RECORD OF PROCEEDINGS CONCORD TOWNSHIP BOARD OF TRUSTEES

Mr. Johnson stated the purpose of the meeting was for the Board of Trustees to consider the re-zoning application #ZC032024, recommended for conditional approval by the Concord Township Zoning Commission Board, that was filed by John Konovodoff with Maronda Homes, 5900 Wilcox Place, Dublin, OH 43016. The Applicant is requesting approval for rezoning from Farm Residential (FR-1) to Planned Residential District (PRD), and a preliminary development plan referred to as Clarkshaw Village on Bean Oller Road, parcels # 419-330-01-009-000 at 12.109+/- acres, #419-330-01-008-000 at 39.200+/- acres, and Clark Shaw Road parcel #419-330-01-016-000 at 12.110+/- acres, Delaware, OH, owned by Dulin Farms Ltd.

- The application is for rezoning of FR-1 to PRD for the project known as Clarkshaw Village on 63.63 acres with 95 lots, for a density of 1.49 units per acre, which is within the township Comprehensive Plan of 1.5 units per acre maximum.

NO. REVISIONS DATE BY
DULIN FARMS CONCORD TOWNSHIP DELAWARE COUNTY, OHIO		SCALE: AS NOTED DESIGNED BY: JDM DRAWN BY: JAB CHECKED BY: KDK
MOUNDING EXHIBIT		ORIGINAL ISSUE: 05/01/2024 KHA PROJECT NO. 190275001 SHEET NUMBER EX 2

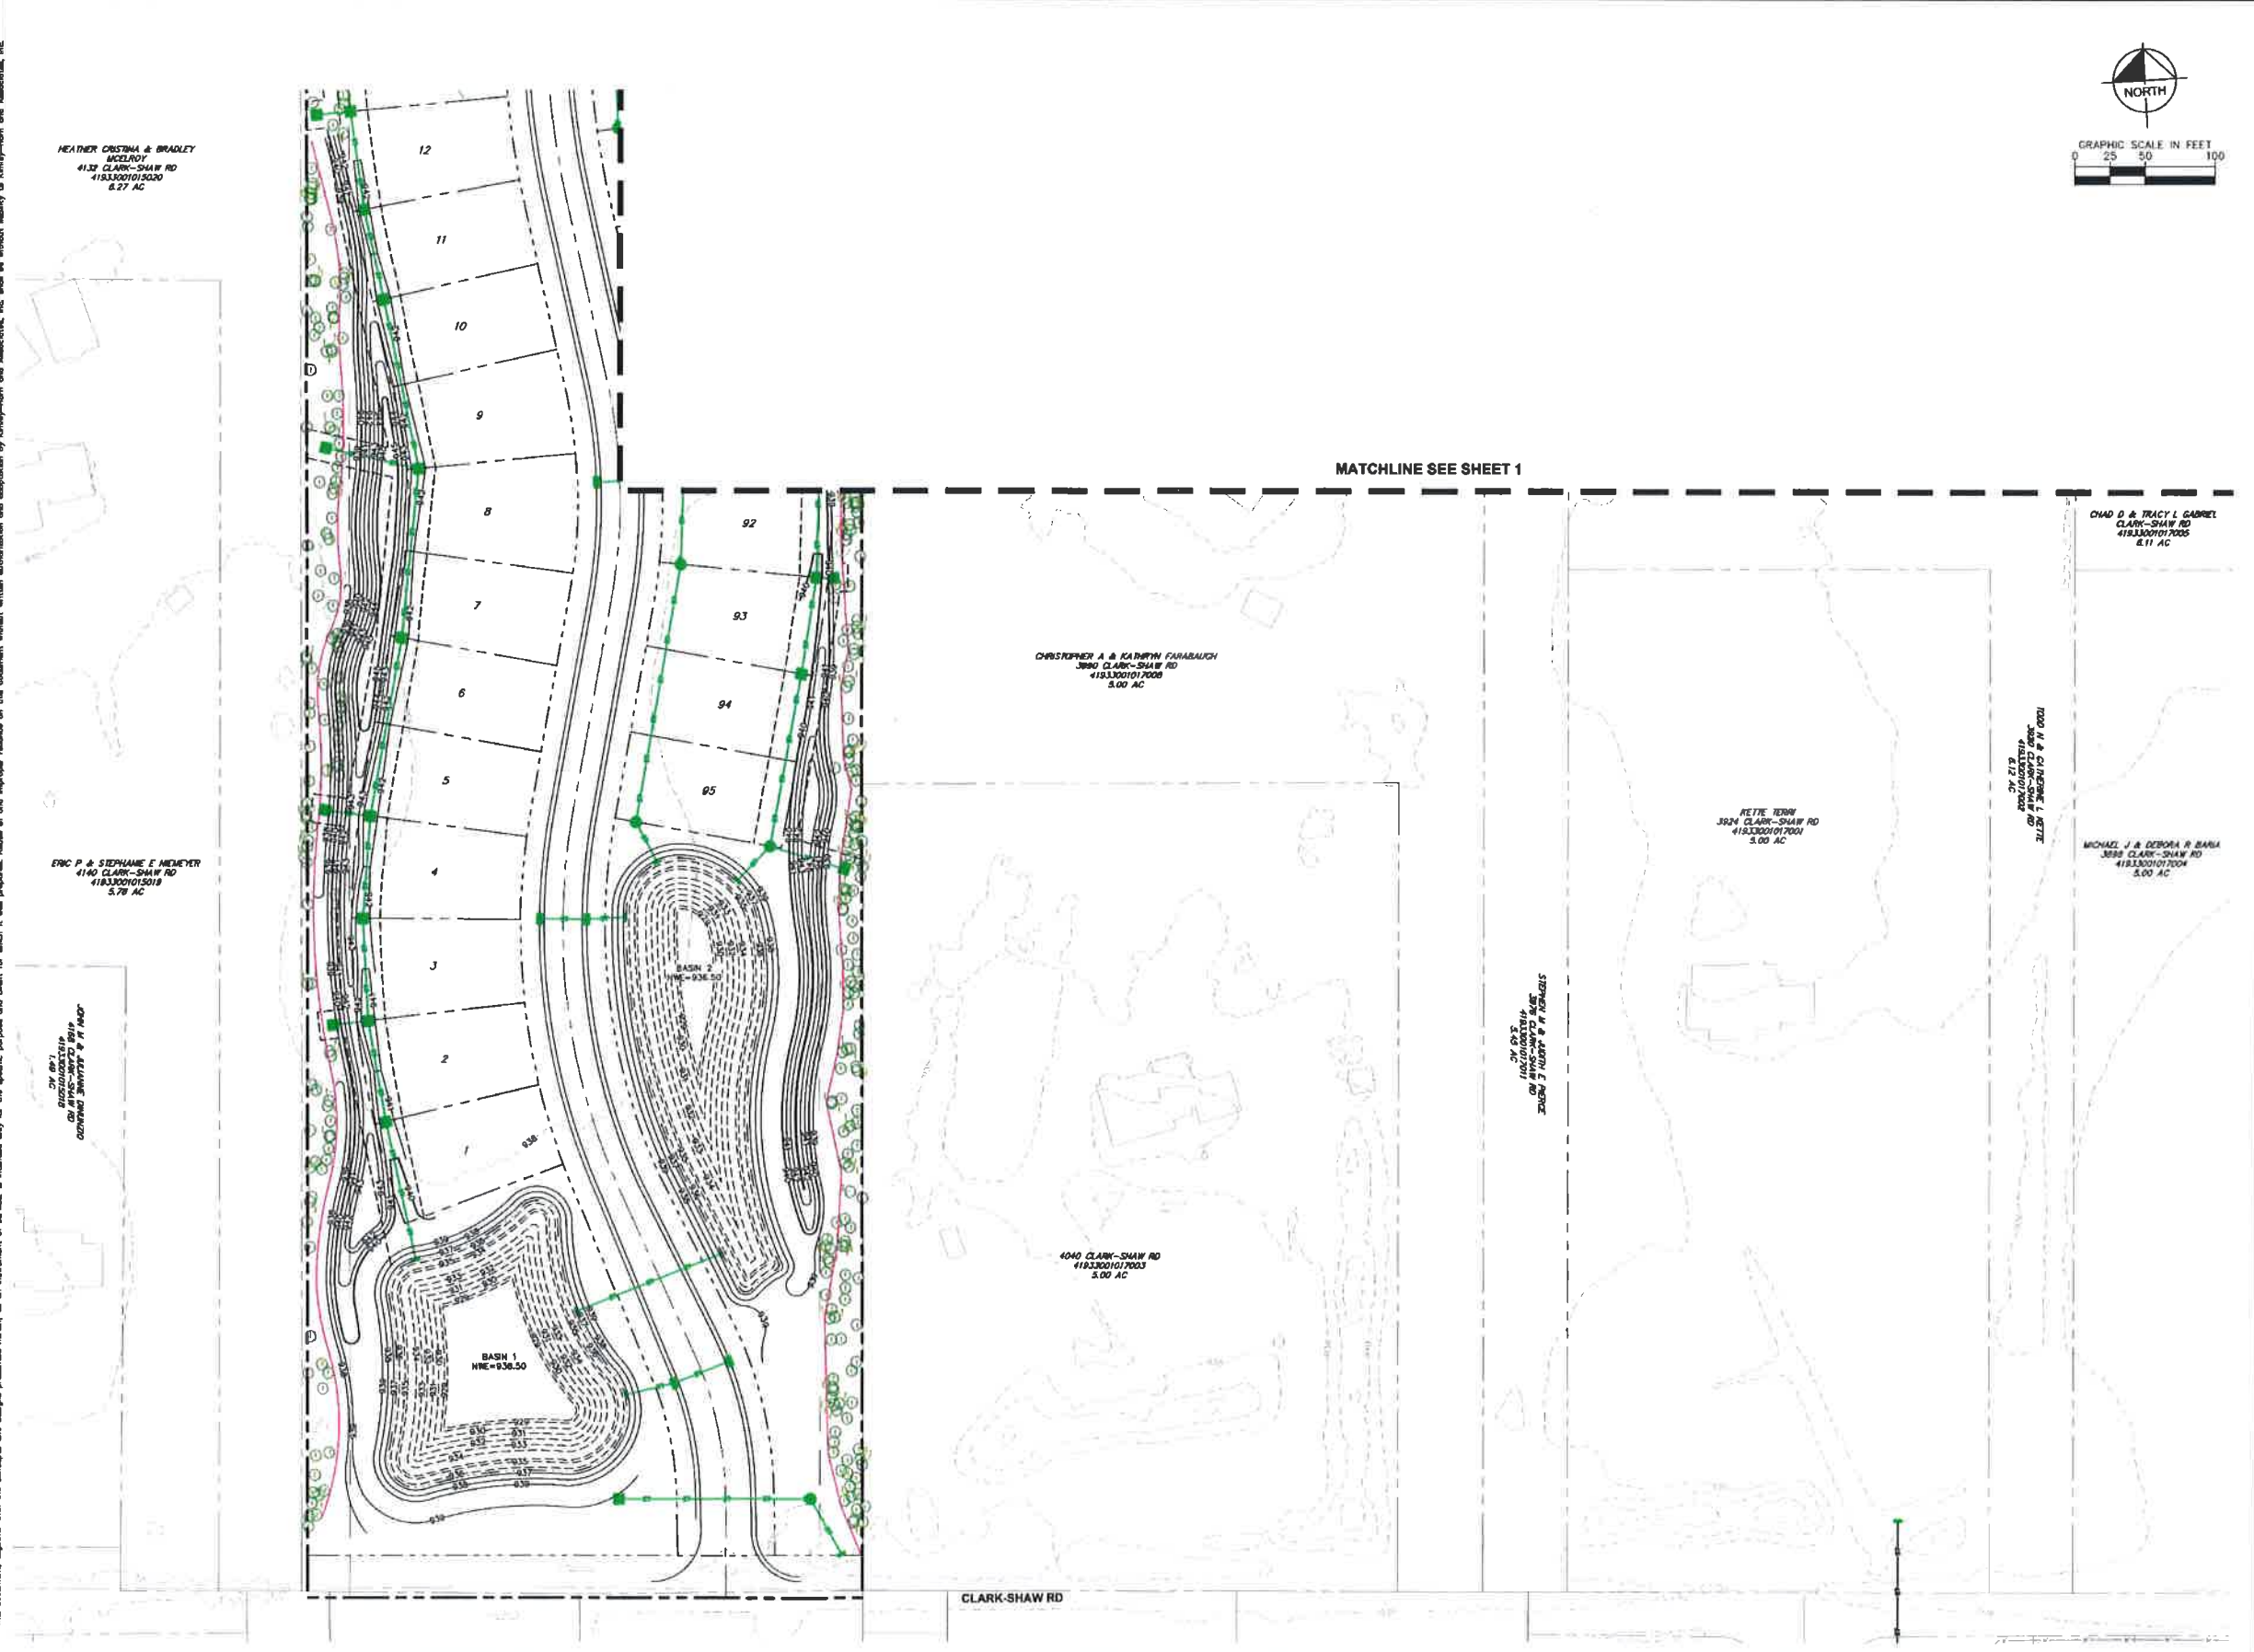
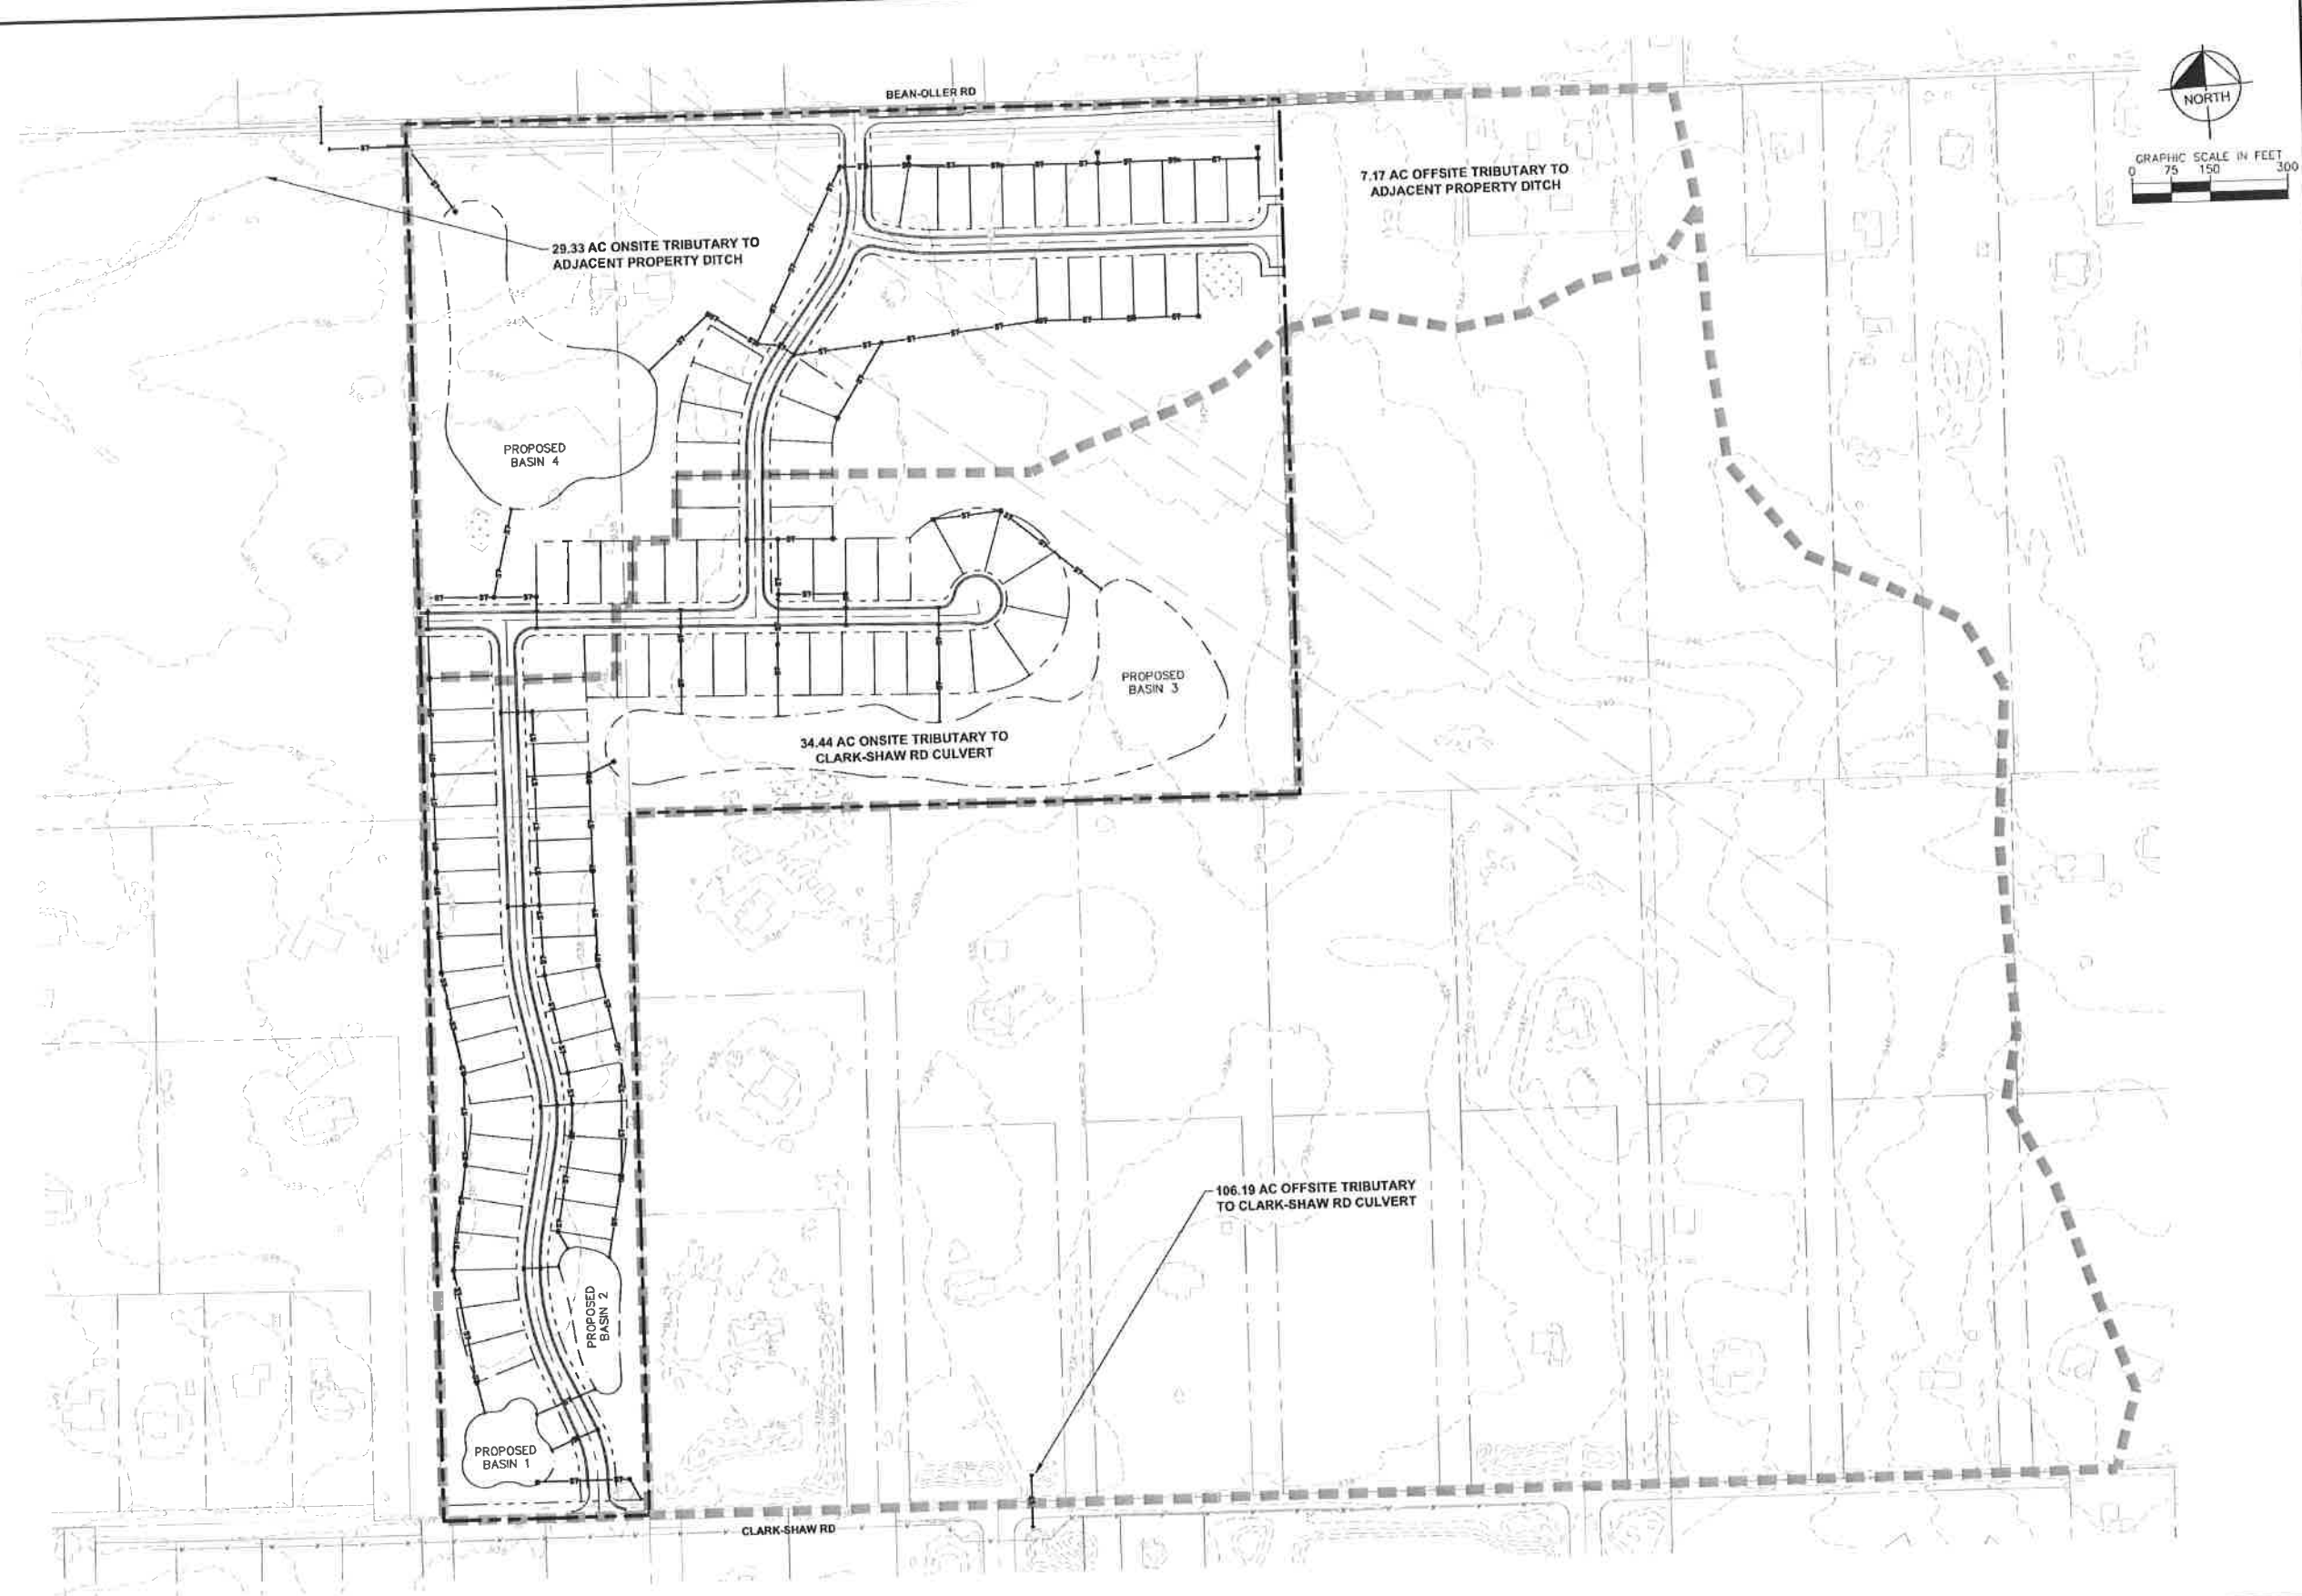
11. Mounding and buffering issues were addressed for lots 35-45 and lots 1-12. The landscaping is still being evaluated. Heavy evergreens and plantings are proposed when the mound goes below ideal height. Mounding may also change based on the Delaware County Engineer's review and storm water locations to collect runoff.
Residents John & Julianne DiNunzio, 4168 Clark Shaw Road, asked why trees were marked? Mr. Todd Faris, Faris Planning and Design, clarified the trees that were surveyed were marked. The design favors preserving existing trees and tapering mounds lower, rather than removing existing trees and growth to continue mounding. Existing tree areas were surveyed, and in areas where the mounding tapers to zero, there is existing growth so not much landscaping screening was added.
Resident Mike Baria, 3898 Clark Shaw Road, requested clarification where the basins were located to catch the storm water. He noted there is a lot of water shed across the property/farm field. The engineer noted the basins were marked as green boxes on the exhibit, and they may need to look at the water runoff along the south line mound and southwest corner to possibly add basins there. Trustee Johnson added drainage is usually improved with development since there will be no more sheeting through the farm field. He noted the Delaware County Engineer's office is very good with storm water management which needs contained throughout the site.

11. Provide to the Trustees details for the additional mounding and buffering issues for the adjacent properties: topography is to be considered, with minimum 7-8 ft. height mounds, taller trees; also improve buffering for proposed lots 35-45 and lots 1-12.

- The mounds on the north property line are 7-8 feet in height.
- Moving north to south along the east property line we have a 9 ft mounds tapering to 0 ft and then back to a 4 ft mound along the proposed pond.
- Moving north to south along the west property line we have a 0 ft mound tapering to 6 ft and then back to a 4 ft mound by the proposed pond.
